State of New Mexico
 Energy, Minerals and Natural Resources

WELL API NO. 30-015-20950
5. Indicate Type of Lease STATE <input checked="" type="checkbox"/> FEE <input type="checkbox"/>
6. State Oil & Gas Lease No.
7. Lease Name or Unit Agreement Name Allied State SWD
8. Well Number 1
9. OGRID Number 18917
10. Pool name or Wildcat SWD Delaware
11. Elevation (Show whether DR, RKB, RT, GR, etc.) 3,330' GL/3,315' KB

SUNDRY NOTICES AND REPORTS ON WELLS
 (DO NOT USE THIS FORM FOR PROPOSALS TO DRILL OR TO DEEPEN OR PLUG BACK TO A DIFFERENT RESERVOIR. USE "APPLICATION FOR PERMIT" (FORM C-101) FOR SUCH PROPOSALS.)

PROPOSED PLUGGING
SCHEMATIC

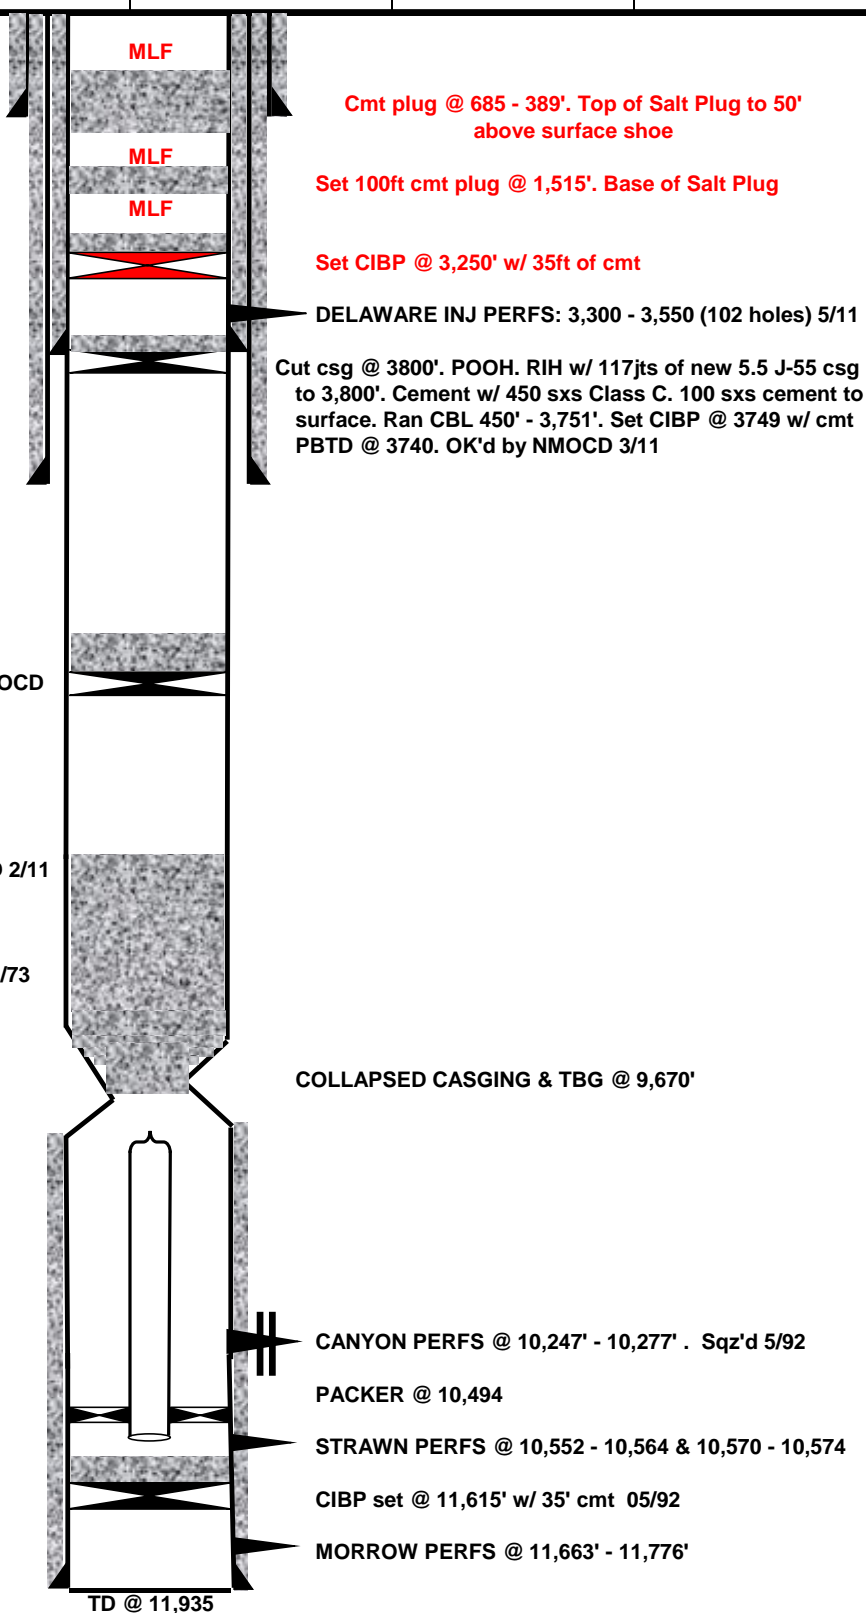
- 1) POOH w/injection tbg & pkr set @ 3,263'.
- 2) Set CIBP @ 3,250' & dump bail 35' of Class C cement to isolate existing Delaware injection perms.
- 3) Set 100' Class C cement plug at 1,515' across base of salt section. WOC & tag.
- 4) Set Class C cement plug across surface casing shoe & top of salt section from 389' to 685'. WOC and tag. **Spot 25 sx Cmt 100' to surface**
- 5) Cut off wellhead & install dry hole marker.
